Greenwood Creek Bridge Replacement Project In Mendocino County

MEMORANDUM

SUBJECT: Evaluation of Wetland Delineation Data Sheets and Maps for the

Greenwood Creek Bridge Replacement Project

Attachment 6, part 2 of 2

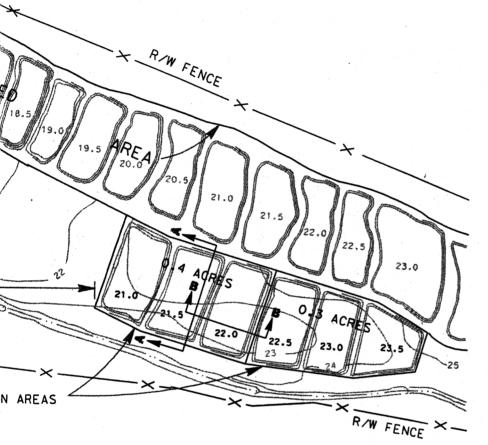
Caltrans' had previously submitted a Wetland Mitigation Plan (Sept. 2004) to Commission staff prior to this CDP application (see Attachment 6). However, this Wetland Mitigation Plan is wholly inadequate. The entire plan submitted to Coastal Commission staff consists of a 1-page diagram of cells to be excavated adjacent to an "existing mitigated area" which was not named. The Wetland Mitigation Plan lacks a comprehensive project description detailing the wetland function and acreage proposed to be lost, and the wetland function and acreage to be gained by the restoration. The Plan's notes describe excavation depth, and the stockpiling and replacement of topsoil, but no accompanying text was included to describe the methodology to be used for restoration and monitoring. In response to Coastal Commission staff's request for a more detailed Wetland Mitigation Plan, Caltrans just submitted additional diagrams of the cell excavation.

A Wetland Mitigation Plan and a Revegetation Plan (for the non-wetland habitat including the coniferous forest) should be prepared by a qualified restoration ecologist and include, at a minimum: a baseline assessment of the restoration site; the goals of the restoration plan; planned site preparation; a detailed planting plan; a plan for reporting upon completion of the initial restoration activities; a monitoring and maintenance plan; final success criteria; the method by which to judge success; a plan for a final report at the end of the monitoring period; and provisions for possible further action.
